**CITY OF BLOOMINGTON
BOARD OF ZONING APPEALS
December 21, 2017 at 5:30 p.m.**

BLOOMINGTON BOARD OF ZONING APPEALS
STAFF REPORT
Location: 722 W 2nd St.

CASE #: UV/V-30-17
DATE: December 21, 2017

REQUEST: The petitioner is requesting a use variance to permit a barber/beauty shop in the Medical (MD) zoning district and a variance from architectural standards.

1 PROPOSED SITE PLAN
1/8" = 1'-0"

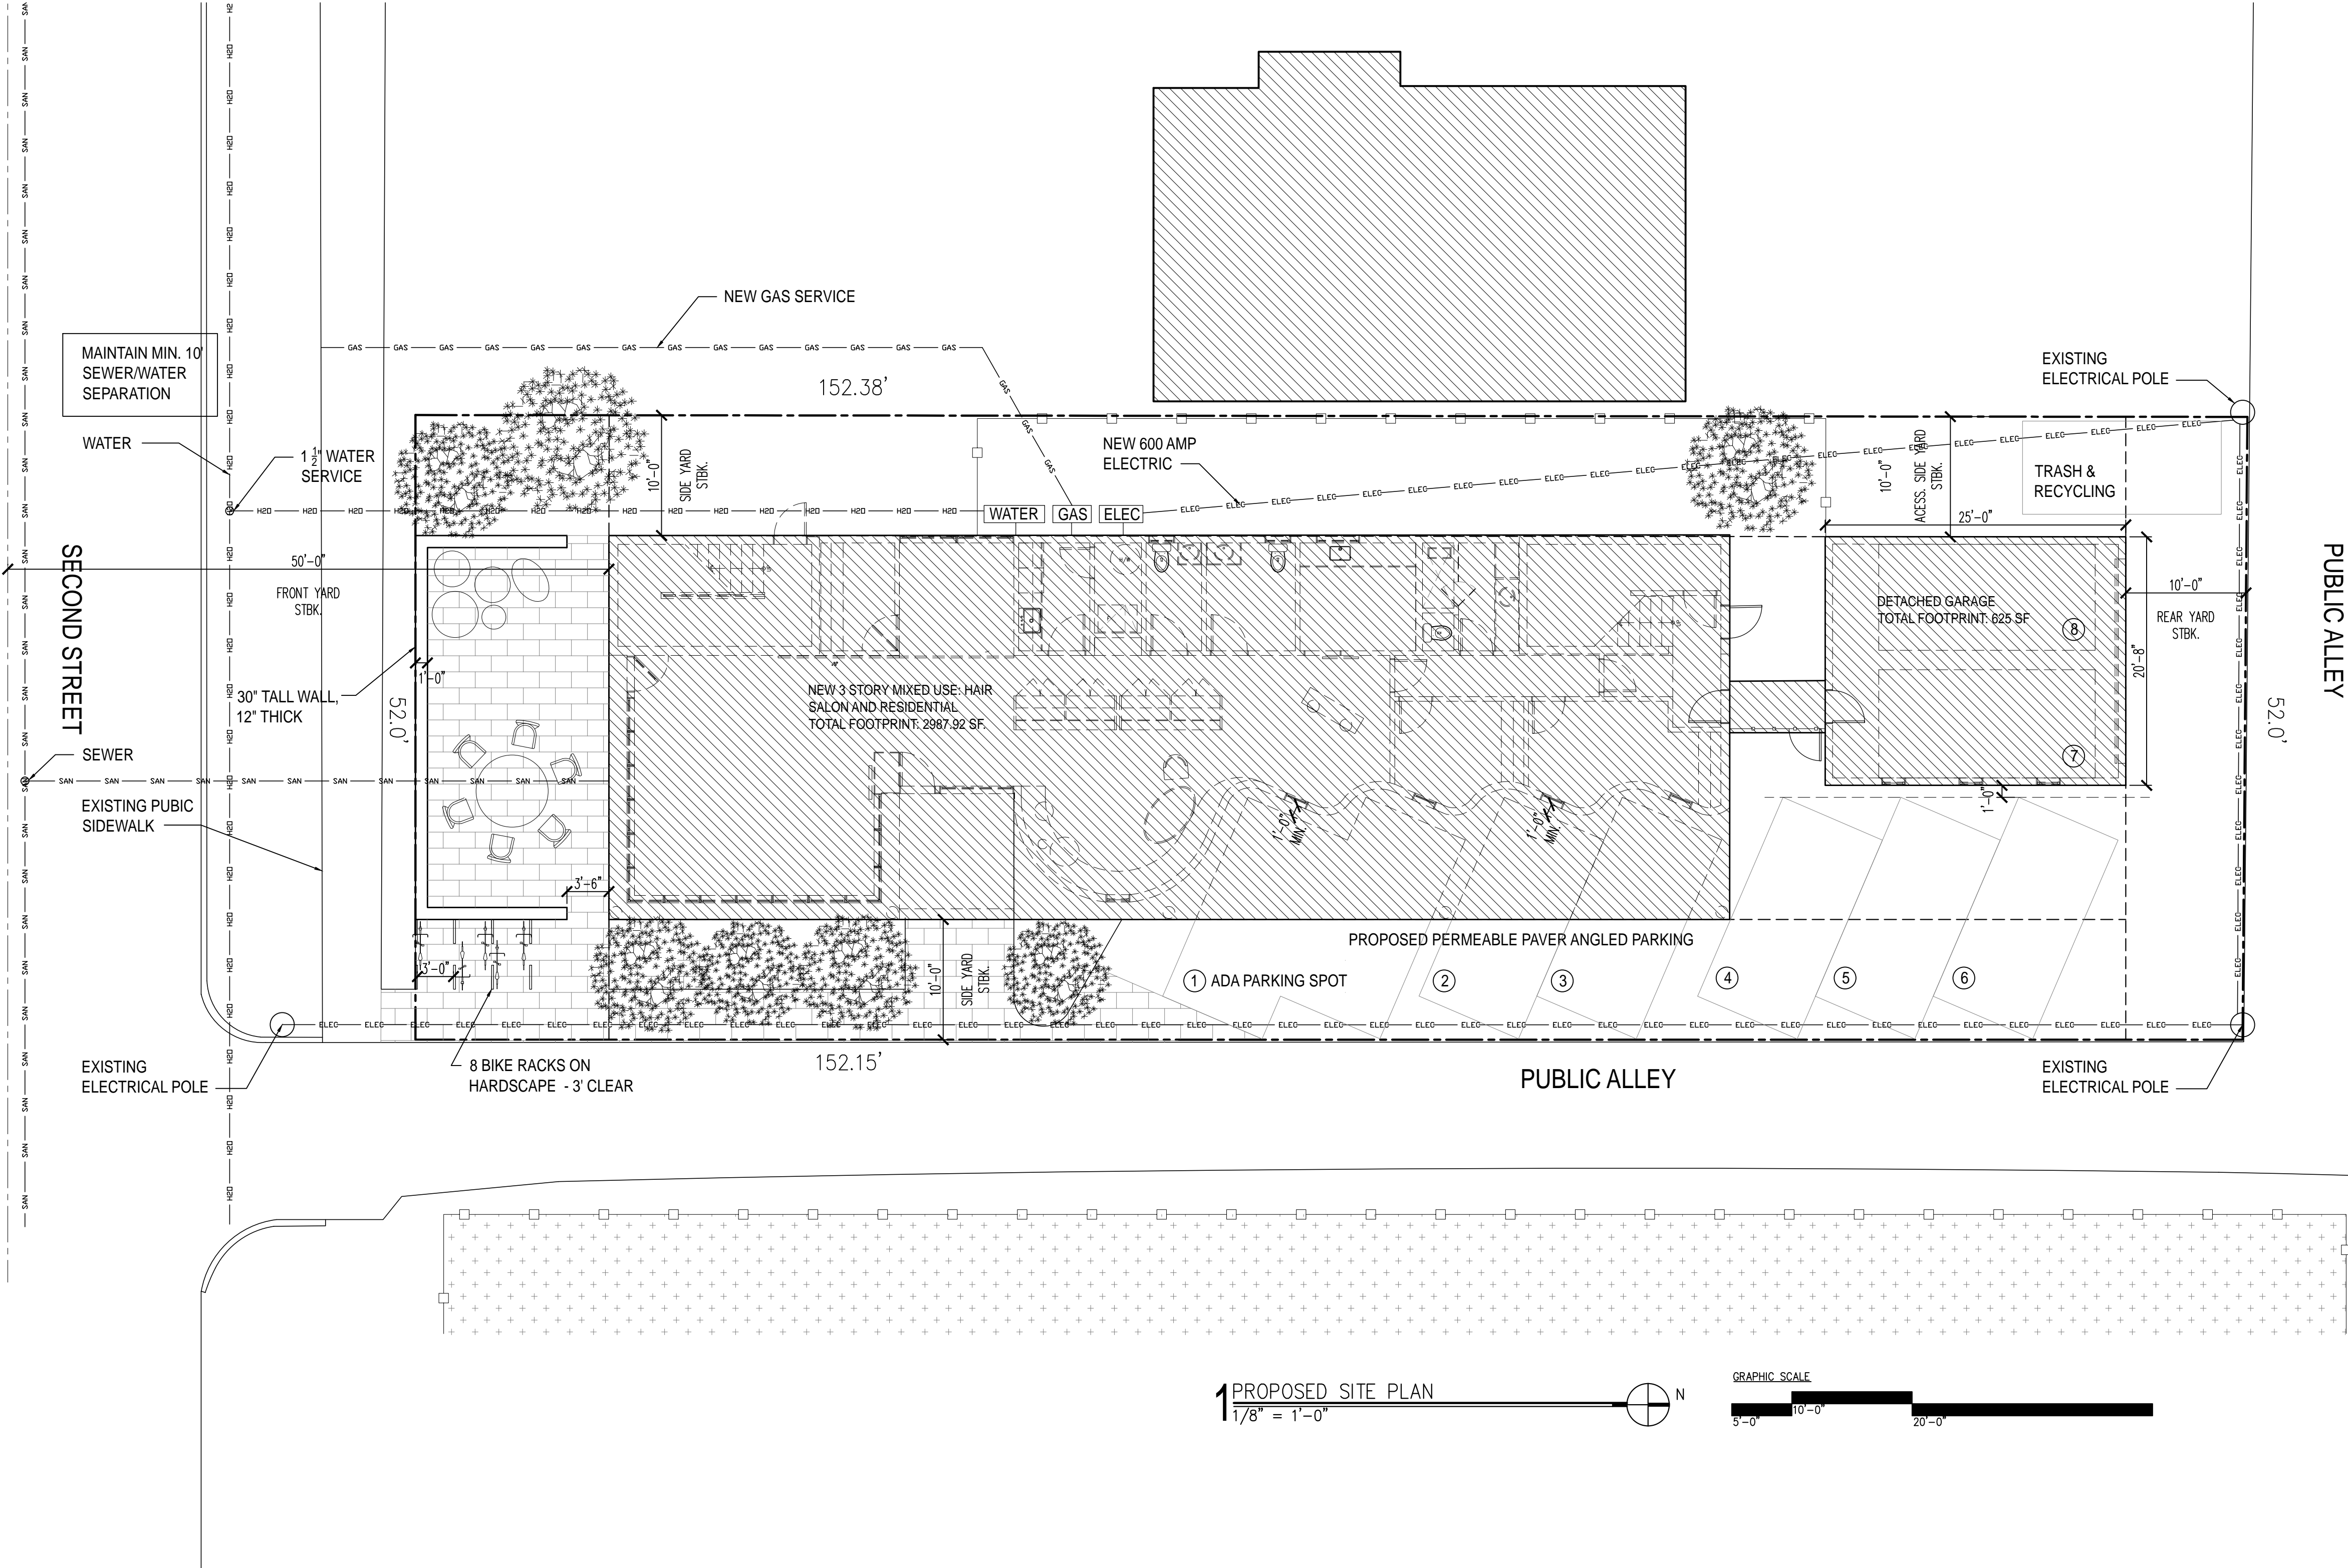
Along the eastern edge of the site are six angled parking spaces. The attached garage at the northern portion of the lot includes two spaces for the owner occupied unit. Per BMC 20.05.070(k), back-out parking within the required side or rear setback may be allowed onto adjacent alleys. This standard limits the number of spaces to eight and requires that the alleys be considered “improved” alleys.

Vehicular access to the site is located at the southwest corner via a public alley.

Bicycle and Pedestrian Facilities: There is existing sidewalk at the south side of the site along W 2nd St. A condition of approval is that the existing curbs shall be modified to meet ADA standards. The UDO requires eight outdoor bicycle parking spaces for visitors and tenants, which are shown on the site plan.

The primary entrance for the barber/beauty shop is located on the east façade, at the southeast corner of the building. There is a proposed patio between the building and W 2nd St. serving as a pedestrian connection from the street to the building.

A4.0
Proposed
Exterior
Elevations

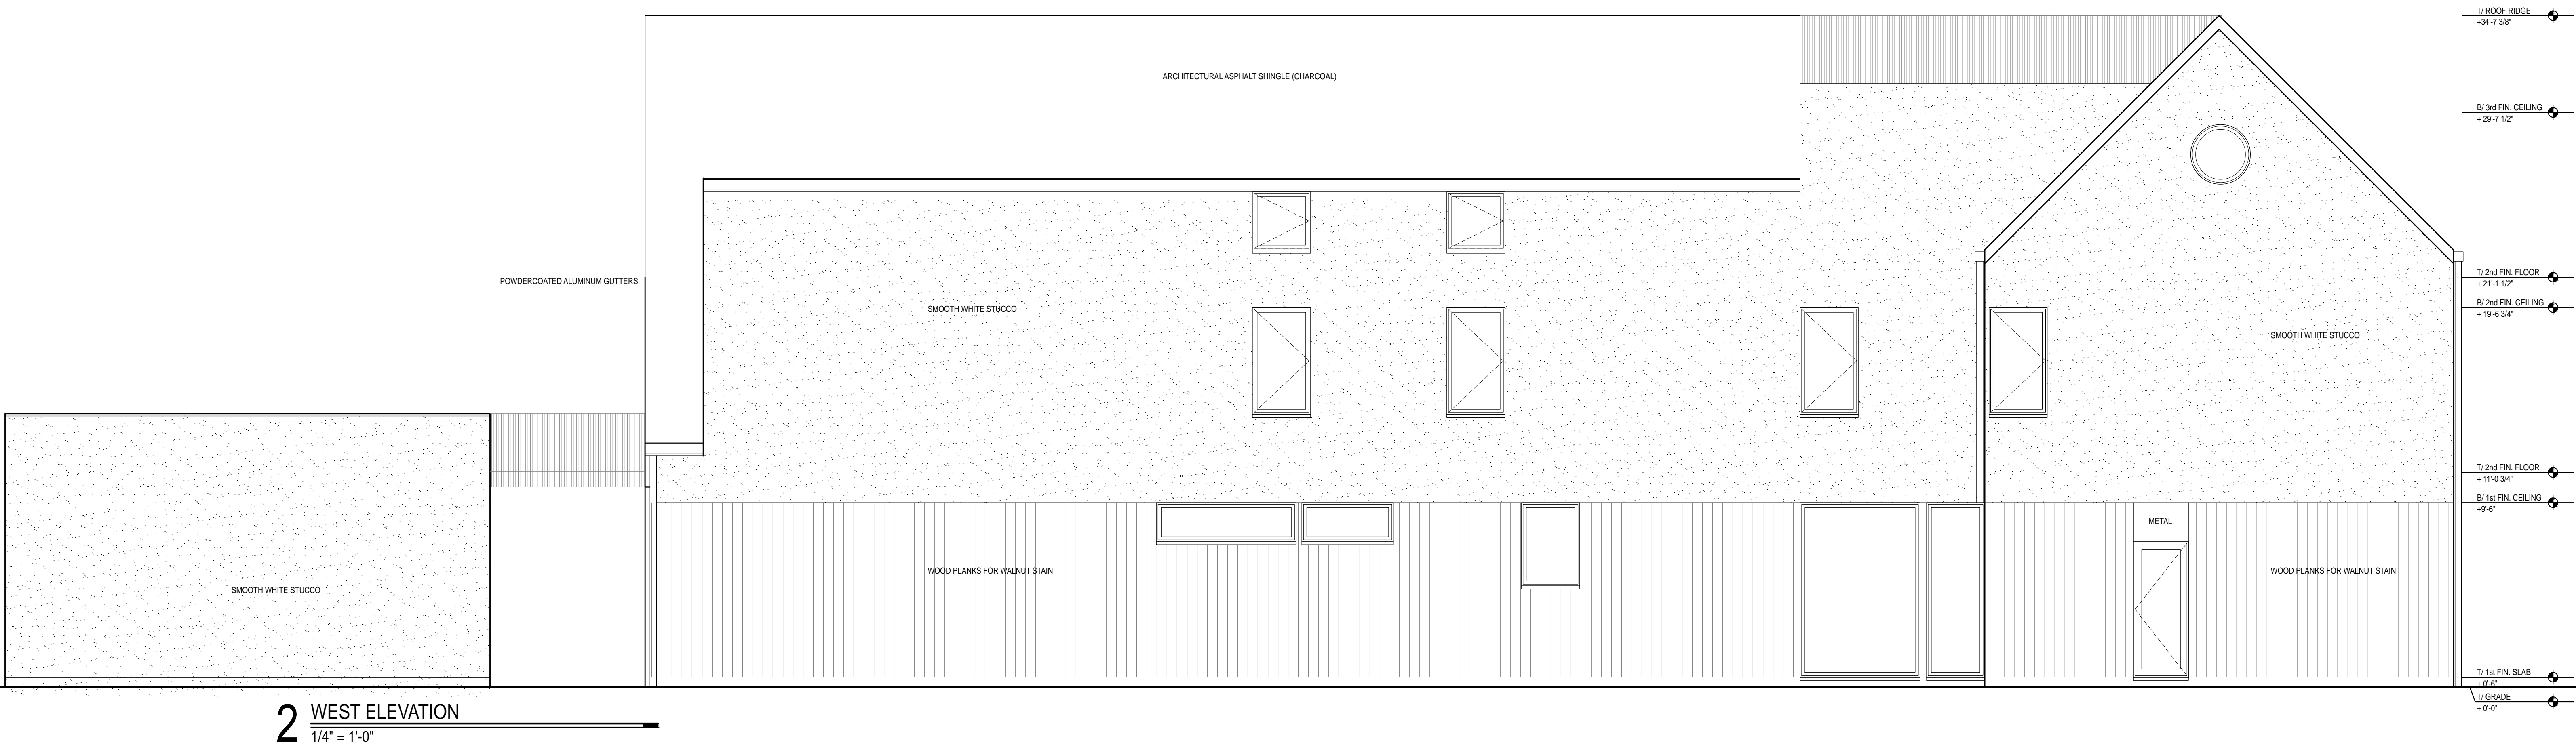
- The proposed material for the street level is vertical wood siding, described as wood planks with walnut stain on the drawings. This will provide a dark wood appearance to the base of the main structure. This floor level is punctuated by vertically oriented fixed window patterns, consistent with the overall modern appearance of the structure.

- The windows on all facades have been modified from the original submittal to be more consistent in their design and vertical alignment. Where they are still not in complete alignment, they appear to be considered in their relationship to other windows and façade elements, and are no longer visually bothersome.

- No material description has been provided for the inset balcony railing at the second floor or the rooftop level balcony. The visual depiction of the material screening the connector to the garage appears to be similar. It would be helpful to have the petition clarify both materiality and color on those items.

- No elevation was provided for the garage door side of the attached garage off the east-west public alley.
- It would helpful to have the petitioner clarify the following minor items:
